CITY OF UNALASKA

ADDENDUM 04

**SUBJECT: INVITATION TO BID
UNALASKA PYRAMID WATER TREATMENT PLANT – LT2 UPGRADE
PROJECT NUMBER: DPW # 13401**

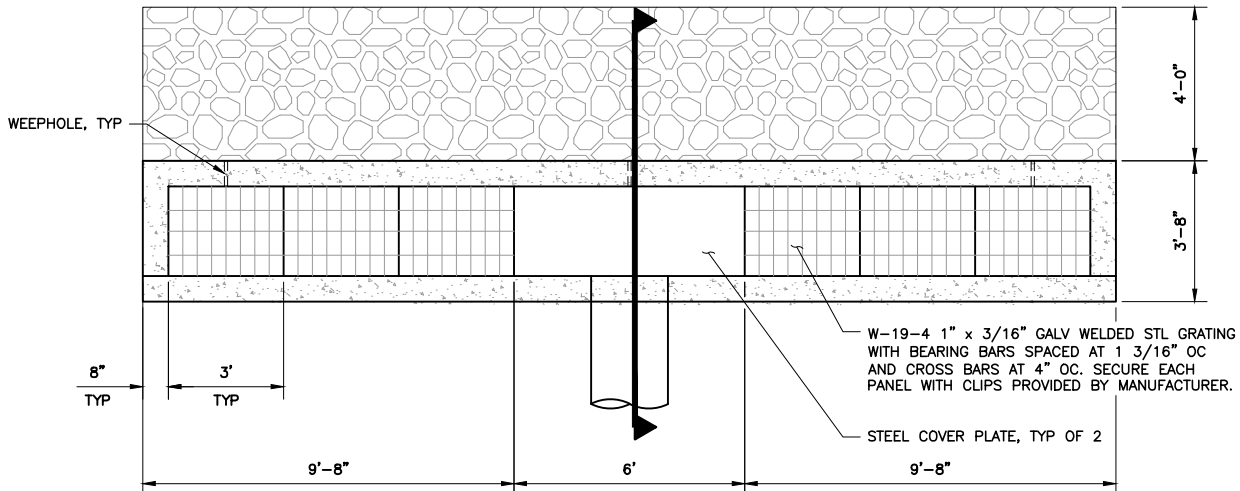
Q.12. Specification Section 13121 paragraph 1.04.A. The above specification for thermal performance on the roof and wall panels indicates a K-factor of .14 btu/sf/hr./deg at a 75F degree mean temperature. Minimum thermal requirement for $k=0.14$ is equivalent to an $R=14.19$, which will be a 2" panel. See enclosed report. Please provide confirmation that 2" panels are correct as other buildings in Dutch Harbor have 4" panels.

A. K value is independent of thickness. Panels are to be 4" thick to an equivalent of $R=28.6$ as shown on drawings.

DISCHARGE HEADER DETAIL
(FROM SHEET C3.5)

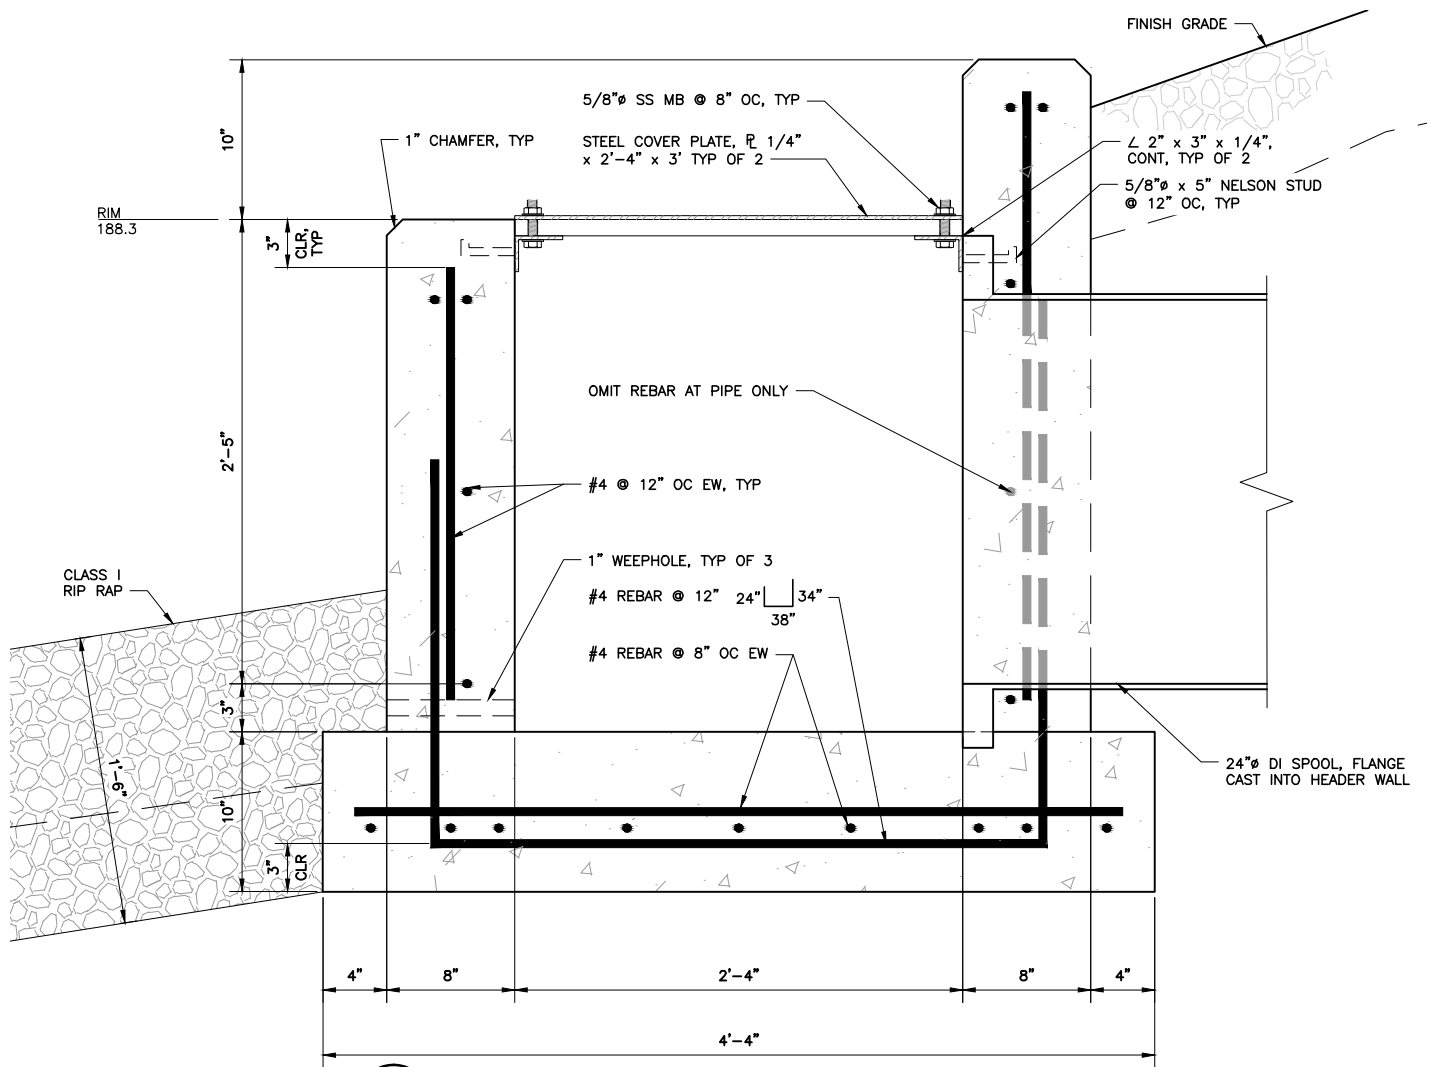
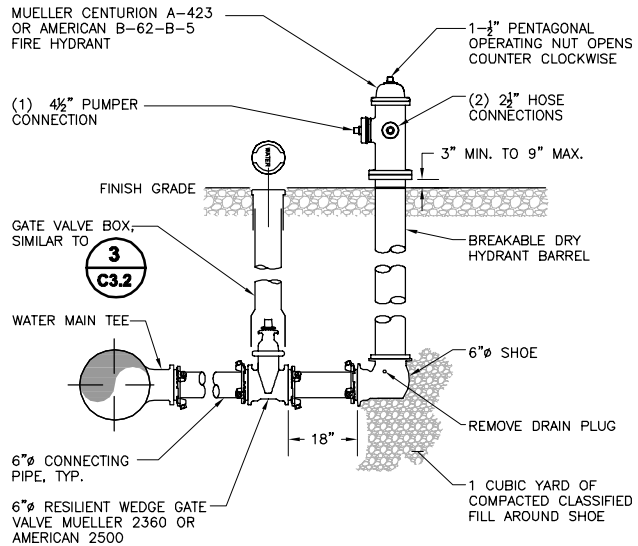
4. Sheet C3.5, Detail 2: Replace “Stainless Steel Manhole Grate per 3/C3.6” with “Steel Manhole Grate per 3/C3.6”.
5. Sheet C3.5: Replace Details 3 and 4 with sketch SKC1 – Discharge Header Detail.

FIRE HYDRANT AND BOLLARD DETAIL
(FROM SHEET C3.3)

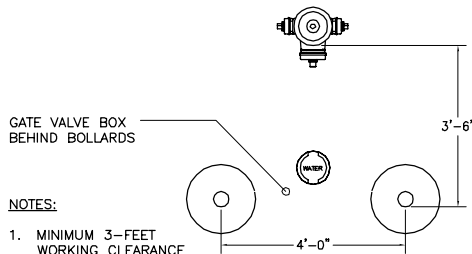
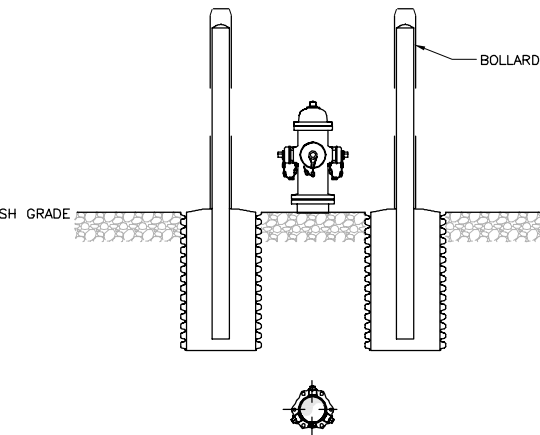
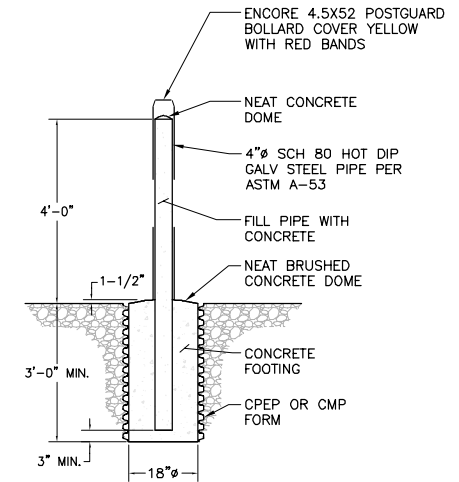
2. Sheet C2.0: Replace “Select Fill” in Grading Note 3 with “Classified Fill”.
3. Sheet C3.3: Replace Details 4, 5, and 6 with attached sketch SKC2 - Fire Hydrant and Bollard Detail.

**PROCESS PIPING MODIFICATION
 (FROM SHEET P1.6 & P2.0)**

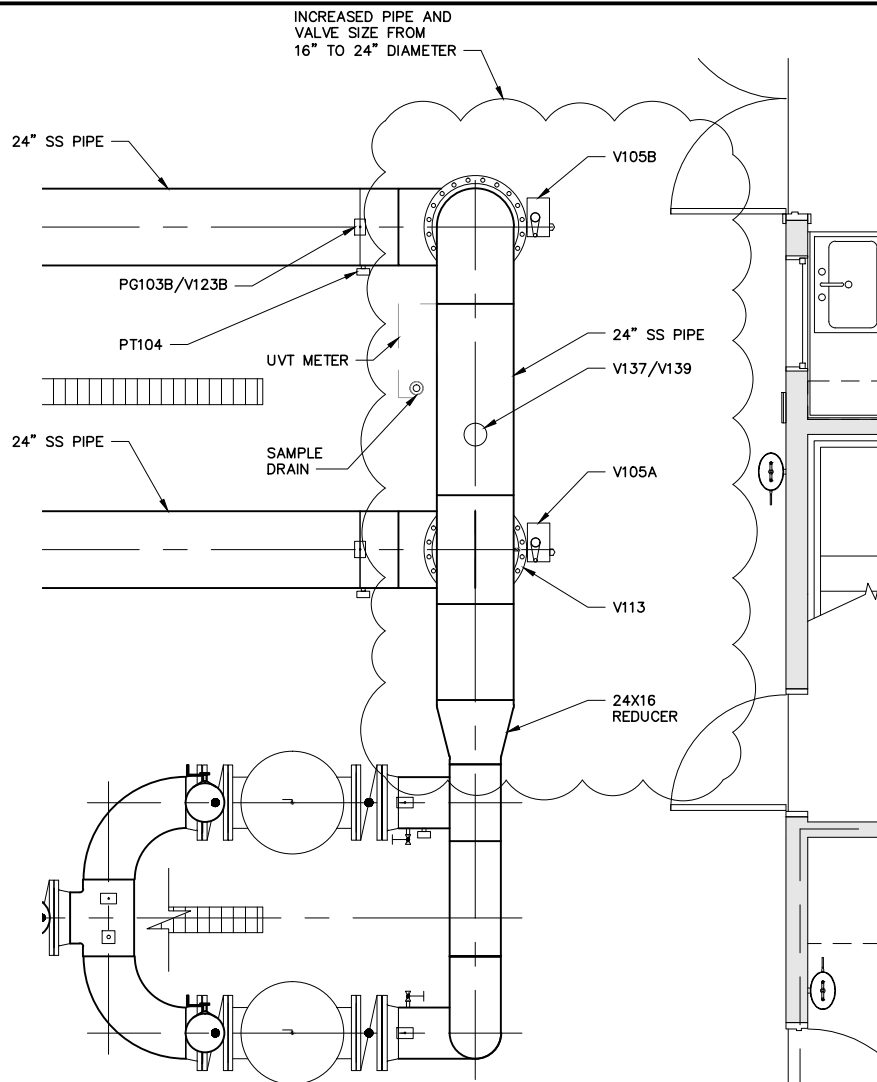
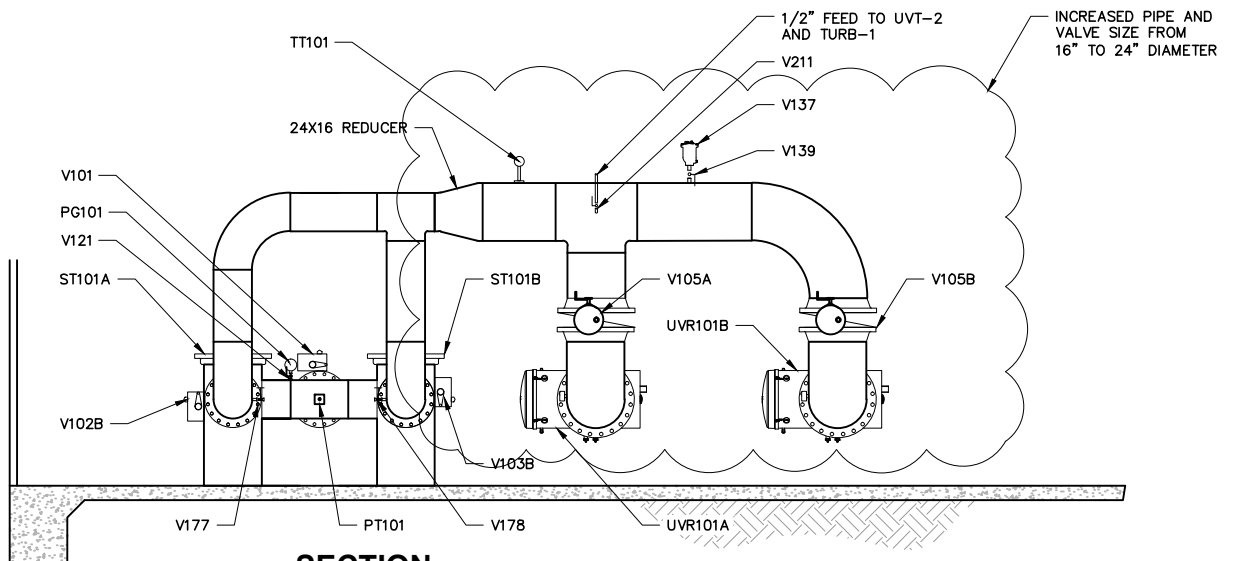
8. Sheet P1.6: Replace callout “V113” with “V211 flow to UVT-3 and TURB-3”.
9. Sheets P1.6, P2.0: Replace 16” diameter process piping immediately upstream from UVR101A and UVR101B with 24” piping as indicated on sketch SKC3 - Process Piping Modification.
